AGENDA
PLANNING AND ZONING COMMISSION MEETING
CITY OF CREVE COEUR, MISSOURI
MONDAY, APRIL 20, 2020

1. Application #20-007: New LED Parking Lot and Building Lighting for the Dielmann Recreation Complex at 11400 Olde Cabin Road

Conway Johnson III, RWA, on behalf of Union Electric Company d/b/a Ameren Missouri, has submitted an application for a conditional use permit, and site development plans to allow for a new Substation at 11685 Olive Boulevard, Creve Coeur, MO, 63141 to replace the existing substation at 11665 Olive Boulevard. Electrical Power Distribution Systems (NAICS 221122) are permitted with conditions in the CB-Core Business District with review at the Planning and Zoning Commission and approval by the City Council.

Figure 1: Close-up of sheet E-1 showing placement of new light fixtures.

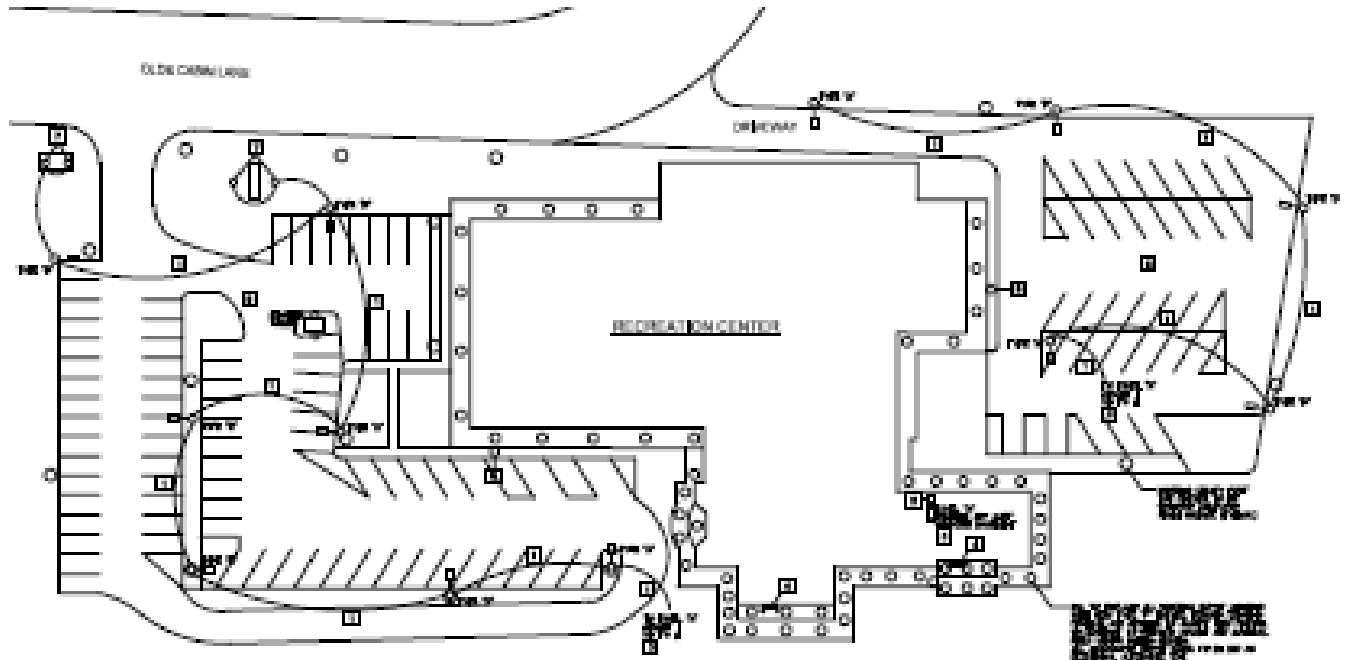
The existing parking lot lighting consists of non-conforming, 15 residential post top carriage style lights, two cobra head lighting on the antenna, and three wall-mounted lights. These will be replaced with 12 new LED in the same standards as those that were installed for the Police Station parking lots. The overall height of the poles will be 20 feet above grade. The 58 lights on the underside of the soffits around the building will also be replaced with the LED canned lighting. New uplights will be added for the sign and artwork installation, near the entrance drive along Olde Cabin Road.

Figure 5: Close-up of the proposed Landscape Plan and Material Schedule, with the area for additional planting is needed.

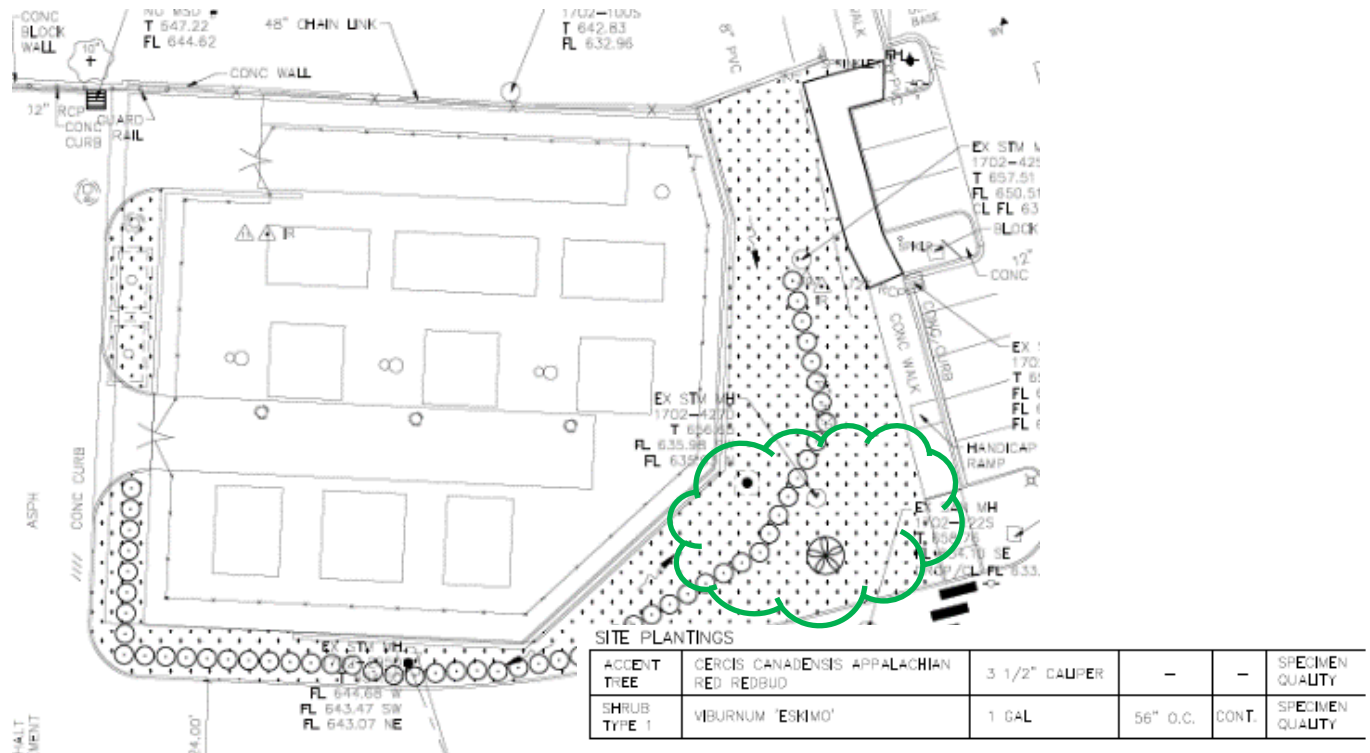
The City's Design Guidelines also offer further review of such utility facilities that include that all on-site utilities (electric, telephone, cable TV) shall be installed underground. Surface transformer switching pads shall be located and screened to be unobtrusive (Ch 5, C. Utilities, p. 18). The proposal is moving the substation further away from Olive Boulevard. The development will sit lower than Olive Boulevard and the adjacent cross-access drive by approximately five feet at the highest, and the Applicant's Landscape Plan includes a hedge row of deciduous shrubs *Viburnum 'Eskimo'*. This is a compact shrub (deciduous in St. Louis) that typically matures to 4-5' tall and as wide. Showy white flowers bloom profusely in snowball inflorescences (to 4" diameter) in May, per the Missouri Botanical Garden plant finder website, to provide screening around site. However, discussed further below the planting are spaced at 56 inches apart, so Staff recommends that such planting need to be spaced closer together and allow for layering and greater interest in the overall design, and should be a more solid upright row of evergreen shrubs. Additional plantings are needed around the accent tree at the southeast corner to further the proposal toward the Design Guidelines and the justification for additional site coverage.

Figure 6: Wall profile 1 and 2, with elevation on the left of the chart.

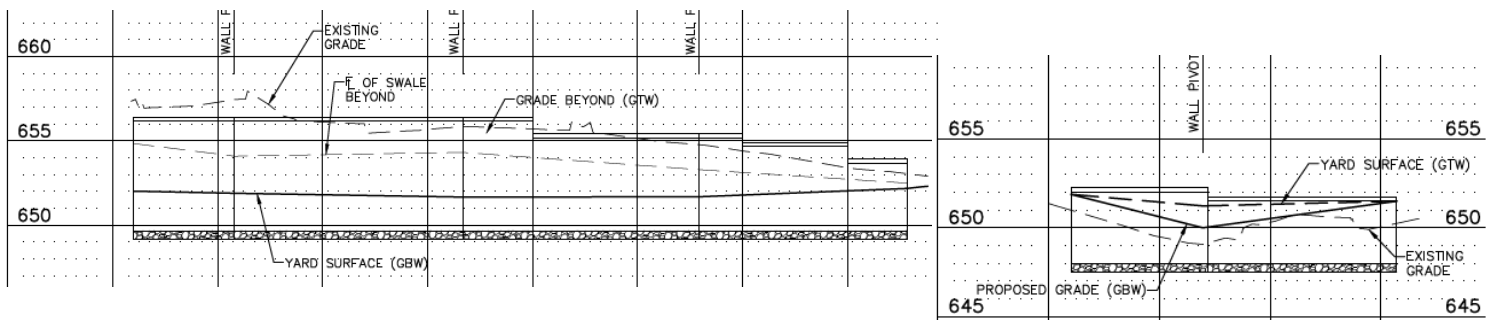
The City's Design Guidelines recommend Accessory Buildings and Facilities and Fences and Walls are to be compatible with the architecture of the main buildings and should use similar materials, and to minimize the height and length of the retaining walls and screen with appropriate landscaping, and designed to incorporate elements of other architectural features or natural features of the project. Additionally, retaining walls in excess of 4-feet in height should be terraced with planting area terrace separation between levels, and materials utilized for the retaining wall should match the primarily building materials. The retaining wall is internal to the site and is approximately 5 feet in total height. Details on the material for the retaining wall were not provided, and the equipment is a light grey. Staff does recommend that the retaining wall be a dark color, while the equipment is a light grey, a darker retaining wall would blend into the landscaped background.

Figure 7: Coverage Area of the proposed New Substation

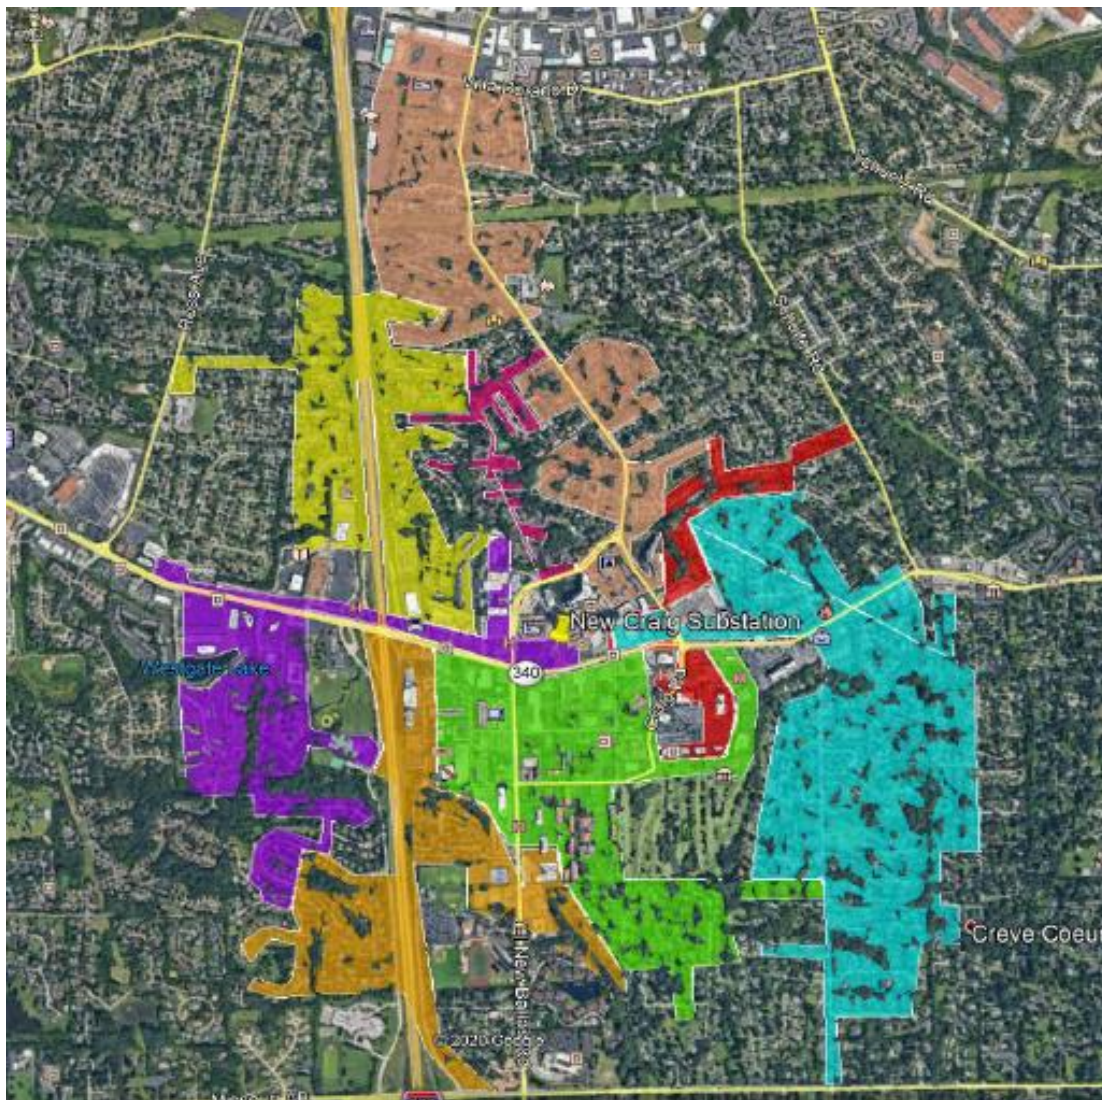
The CB District regulations include a maximum site coverage of 63%, where under Section 405.370(E)(3)(b)(2) the Planning and Zoning Commission may, in its discretion, allow the permitted coverage to be increased as a bonus (not to exceed the total of seventy percent (70%) site coverage) in consideration of special or outstanding landscape and site planning features as demonstrated by a site development plan submitted in accordance with Section 405.1080. As indicated above, the overall proposal includes a total site coverage of 69.3%. Given the public benefit of upgraded electrical facilities that will be able to serve the 2.6 square mile area, the Planning and Zoning Commission may take this into consideration. Below is an image of the service area provided by the new substation. However, Staff does find that additional landscaping is needed to further the proposal towards this requirement and has included a requirement for additional landscaping for the Zoning Administrator's approval.

Figure 8: Close-up of the Applicants Lighting Placement Plan and Schedule

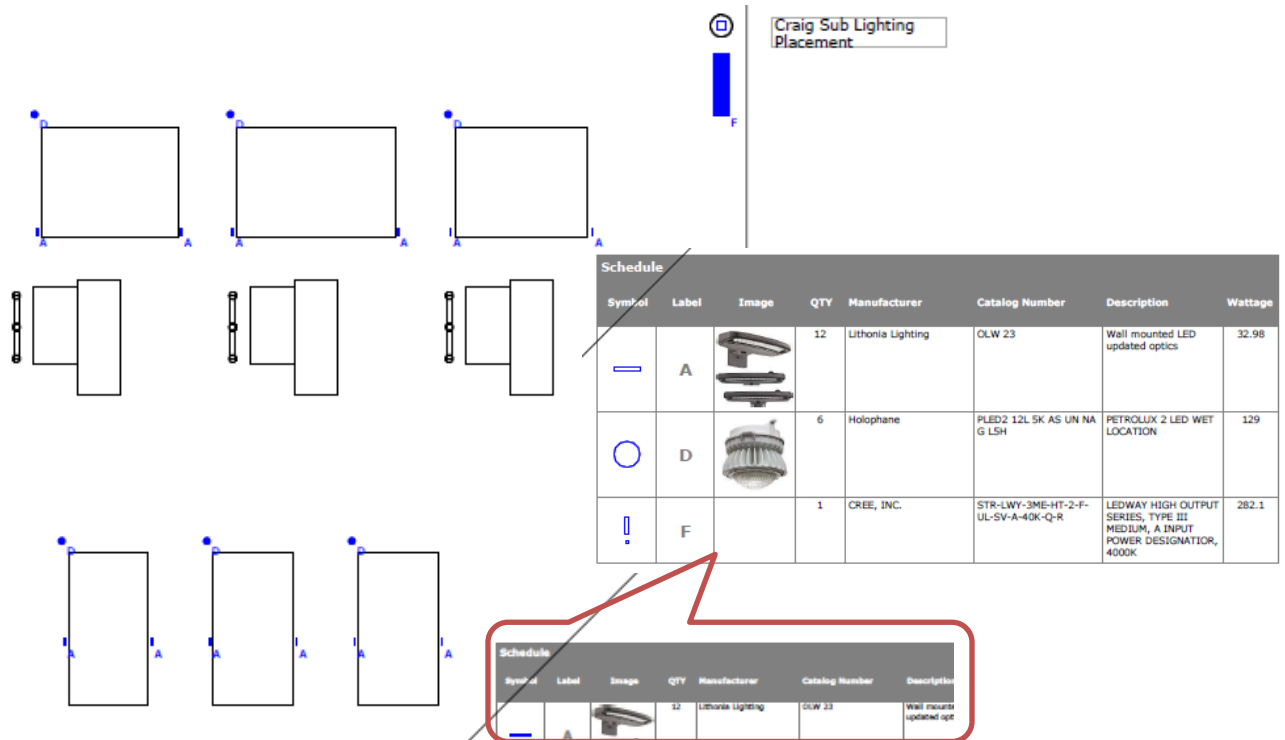
directed outward. The lighting is low level and generally for security purposes, or only when someone is on site, and therefore should not be directed outward, or be cast upon adjacent property.

Figure 9: Close-up of the Site Plan showing the new sidewalk along the east property area

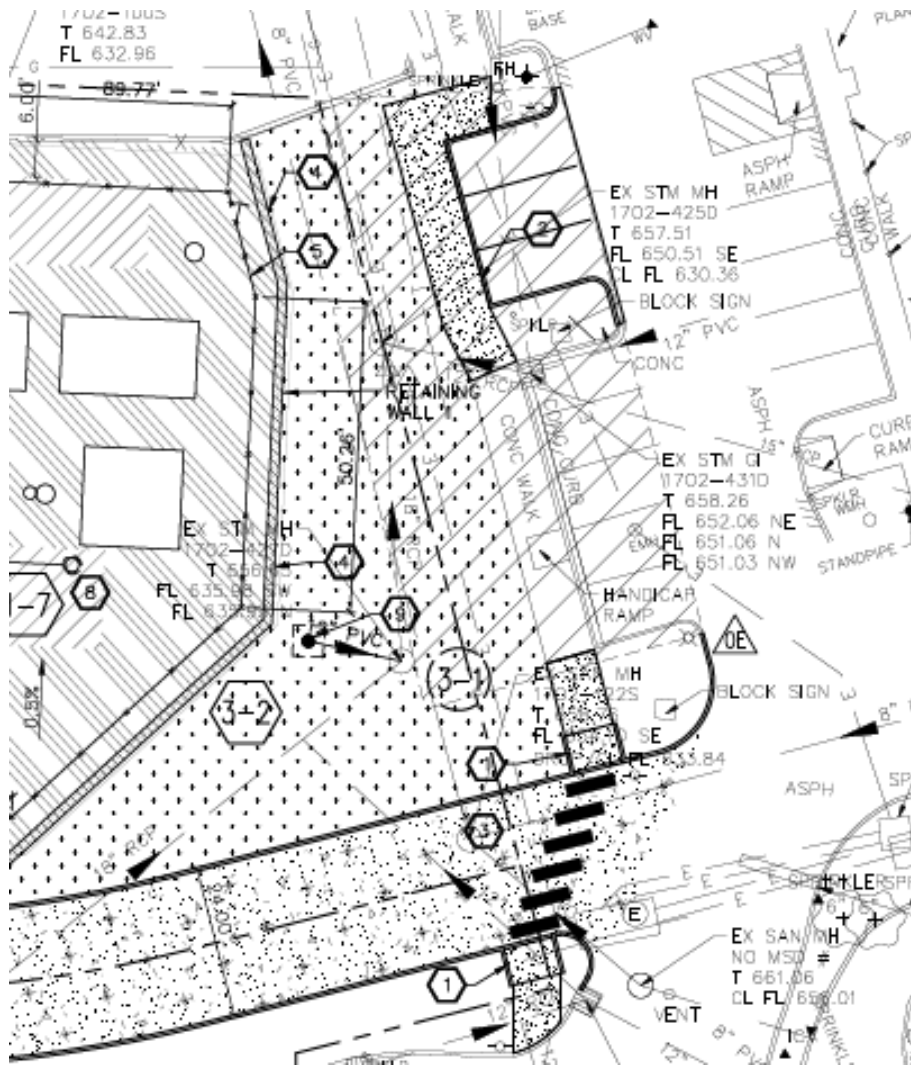
Section 405.730(A)(2) requires that the minimum width of internal sidewalks in non-residential developments shall be at least six (6) feet or eight (8) feet if used as a curb stop. The proposal includes adding additional spaces on City Place property where the existing cross-access is and carrying it southward across the new drive to the parking area for US Bank per the image below. The sidewalk is scaled at 8 feet in width in compliance with these regulations. Staff has not required that a sidewalk be included following along the access drive at this time. Due to the change in grade and to meet with the regulations for accessibility, a sidewalk would best be served on the south side of the drive. In anticipation of the future development on this site, a sidewalk would be provided with the review of a site development plan for this lot.
